Outdoor Accents, JC14-120

Consideration of the request of Outdoor Accents, Inc. for Preliminary Site Plan and Section 9 Façade Waiver approval. The applicant is proposing to occupy the former Timberlane Hardware building at 42780 Ten Mile Road in Section 23 on the north side of Ten Mile Road, east of Novi Road in the I-2, General Industrial District. A change in roof materials is also proposed for the Main Building and Warehouse A.

PLAN REVIEW CENTER REPORT

Façade Review

Site Plan
SCALE 1" = 40'-0"
1 INCH = 40'-0"

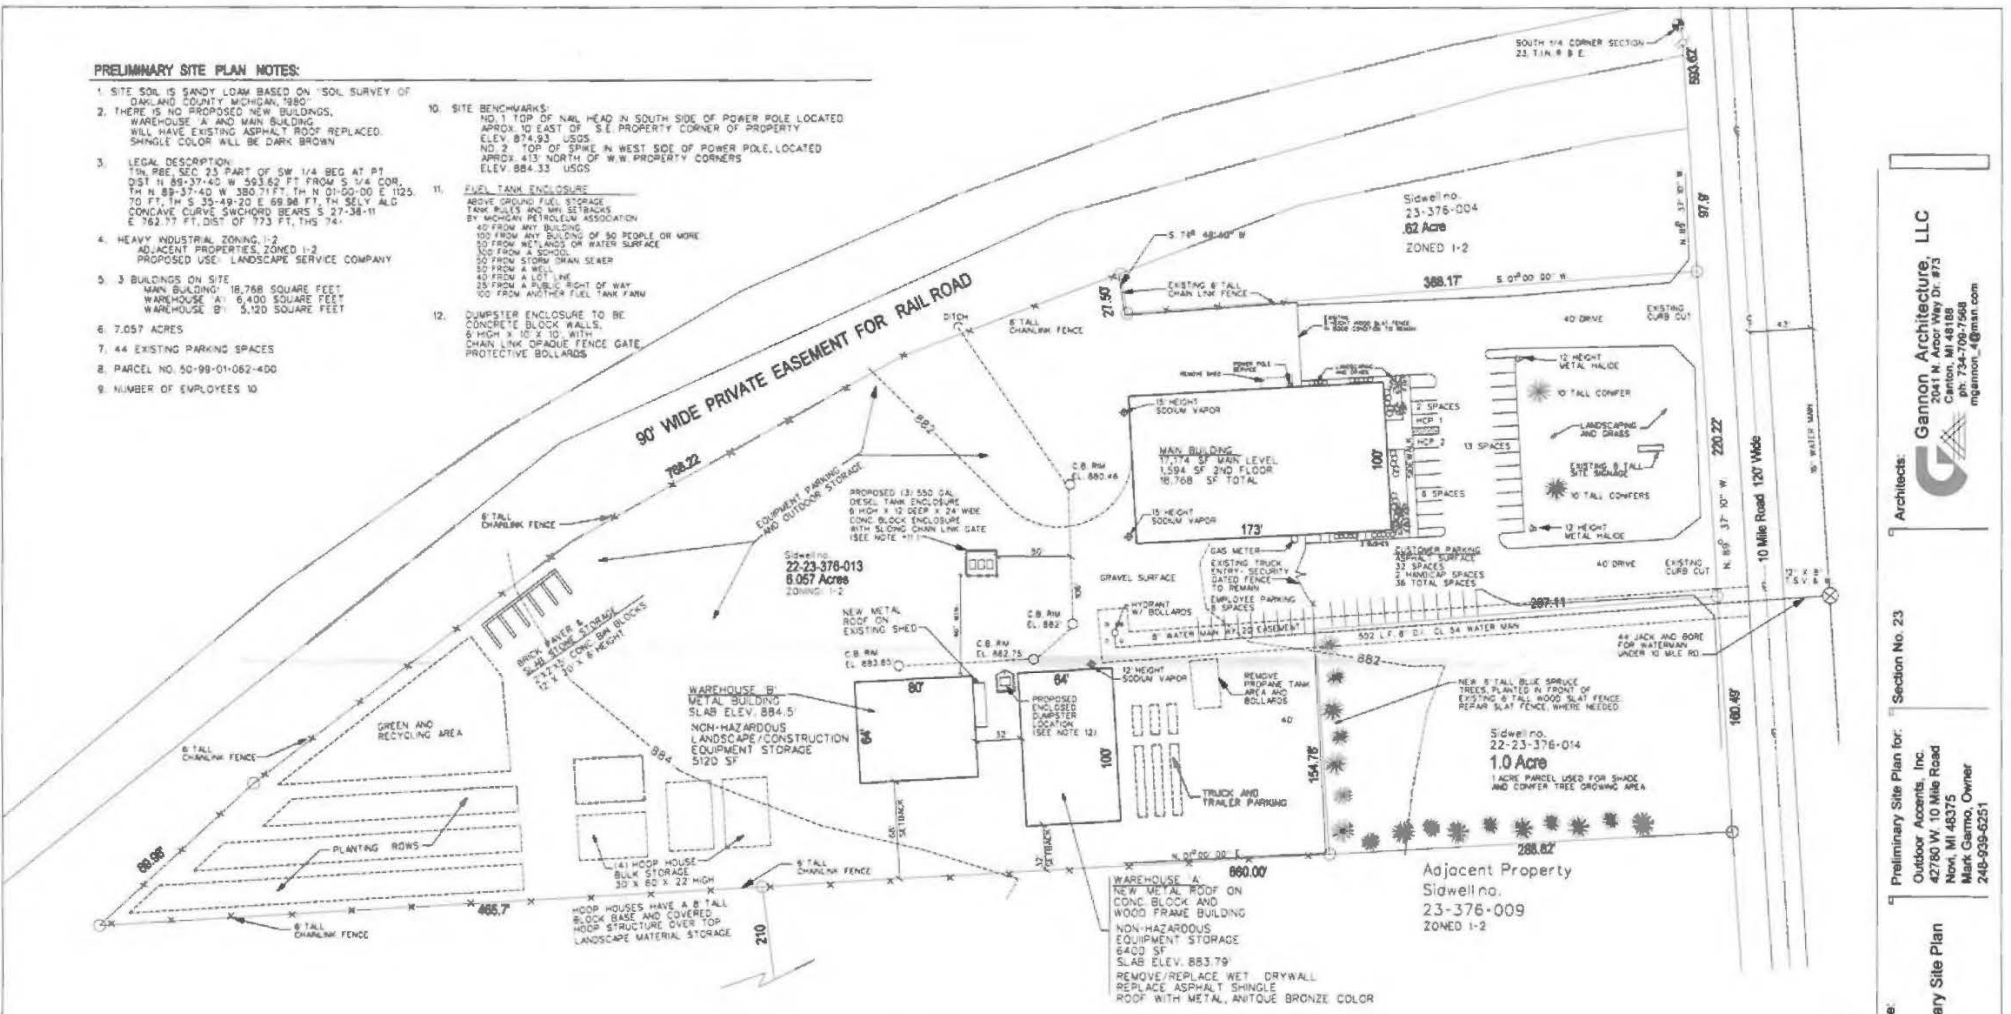
Per Article 20 Sec. 2001.3 any proposed outdoor storage will be required to be screened from view by an obscuring fence/wall, landscape, earthen berms or a combination. Please provide additional detail on materials that may be stored outdoors and how the screening will be accomplished.

- 1) A hazardous chemical survey is required to be submitted to the Planning & Community Development Department for distribution to the Fire Department at the time any Preliminary Site Plan is submitted for review and approval. Definitions of chemical types can be obtained from the Fire Department at (248) 735-5674.
- 2) Entrances to private roadways shall not have locked gates, cables or barricades that would impede fire apparatus response. All locks must be approved by the Fire Department.
- 3) A detailed plan of the fuel storage is required and to include manufactures sheets of all tanks and related equipment.

Sheet Title:
ELEVATIONS
WAREHOUSE 'A'
WAREHOUSE 'B'
MAIN BUILDING

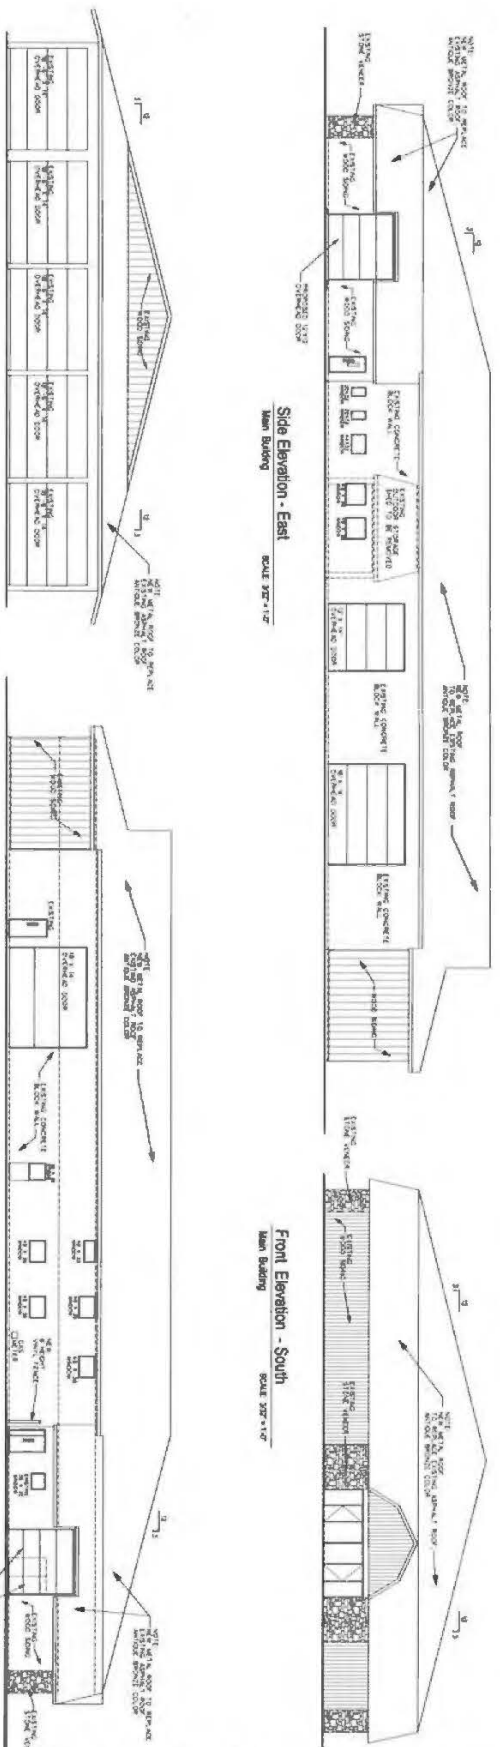
Main Building, 18,700 SF Façade Region 1	South (Front)	West	East	North	Ordinance Maximum (Minimum)
Brick	0%	0%	0%	0%	100% (30% Min)
Standing Seam Metal Roof (bronze)	65%	48%	55%	53%	25%
Wood Siding (Existing)	25%	16%	17%	47%	0%
Painted CMU (Existing)	0%	35%	27%	0%	0%
Stone (Existing)	10%	1%	1%	0%	50%

Warehouse A, 6,400 SF Façade Region 1	South (Front)	West	East	North	Ordinance Maximum (Minimum)
Brick	0%	0%	0%	0%	100% (30% Min)
Standing Seam Metal Roof (bronze)	28%	0%	0%	46%	25%
Wood Siding (Existing)	55%	93%	92%	20%	0%
Painted CMU (Existing)	17%	7%	8%	34%	0%
Stone	0%	0%	0%	0%	50%

As shown above the minimum percentage of Brick is not provided on The Main Buildings and Warehouse “A”. The percentages of Asphalt Shingles, Wood Siding and Painted CMU exceed the maximum amount allowed by the Façade Chart on various facades. These deviations represent pre-existing conditions on facades which are not proposed to be altered. The existing asphalt shingle roof on the Main “B” and Warehouse “A” are proposed to be replaced with Standing Seam Metal. The percentage of this material exceeds the maximum amount allowed by the Façade Chart. In this case the introduction of this material will significantly improve the overall appearance of the buildings.

Recommendation - For the reasons stated above it is our recommendation that this application is consistent with the intent and purpose of the Façade Ordinance and that a Section 9 Waiver be granted for the overage of Standing Seam Metal roof. It should be noted that in the event that painting of any existing façade materials occurs, this would be regulated under Section 2520.2, and revised drawings and a sample board illustrating the proposed colors will be required.
